STAGE 4

project title		KOKO + Hope & Anchor + Bayham Place, Camden, London	
drawing title	Proposed Ground Floor Plan	scale	1:100 A1 13.04.17
drawing number	AHA/KCC/GA/100	drawn	FR/PC
		checked	DA
		revision	C

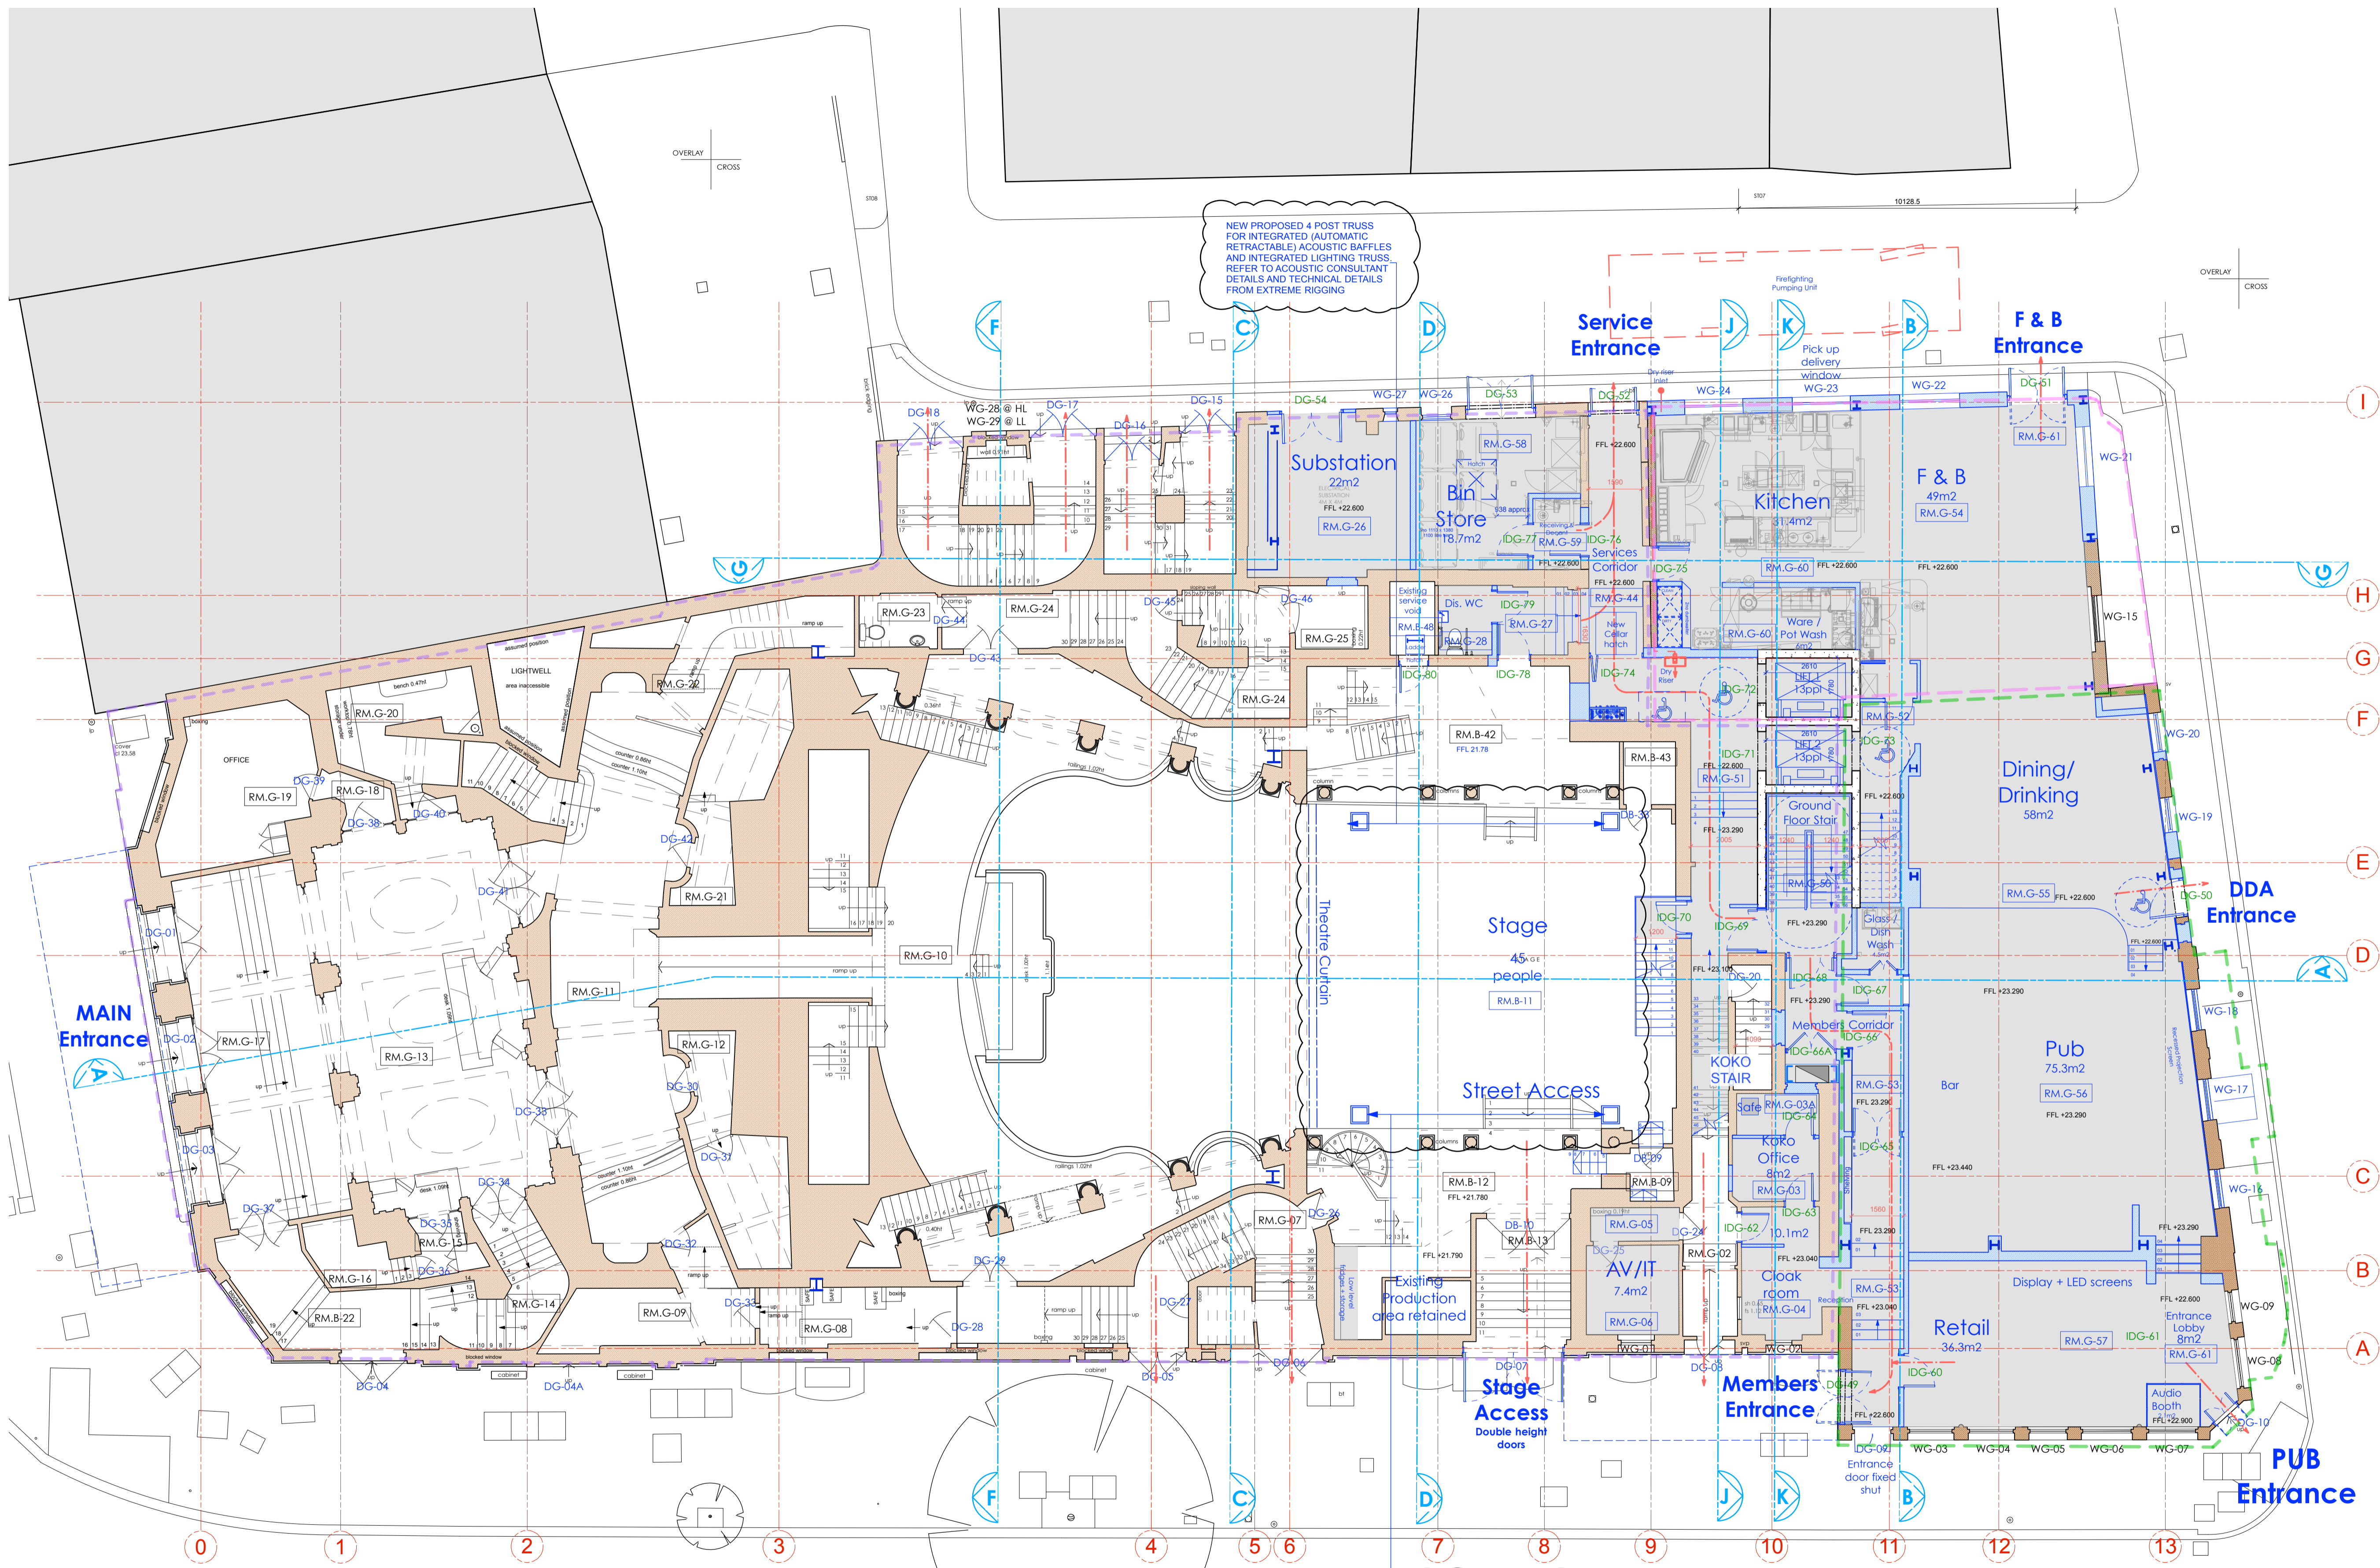
A / 23/03/18 / 1. Tender Addendum (1). Indication of 4 post truss fixed at stage level for integrated automatic retractable acoustic baffles and integrated lighting rig.

B / 12/04/18 / 2. Tender Addendum (2). New AHU + Attenuator over stage to be hung to existing relocated secondary beams in Flytower.

C / 01/06/18 / - Door and window numbers updated
Listed Building Application
1. Indication of 4 post truss fixed at stage level for integrated automatic retractable acoustic baffles and integrated lighting rig.
2. New AHU + Attenuator over stage to be hung to existing relocated secondary beams in Flytower.
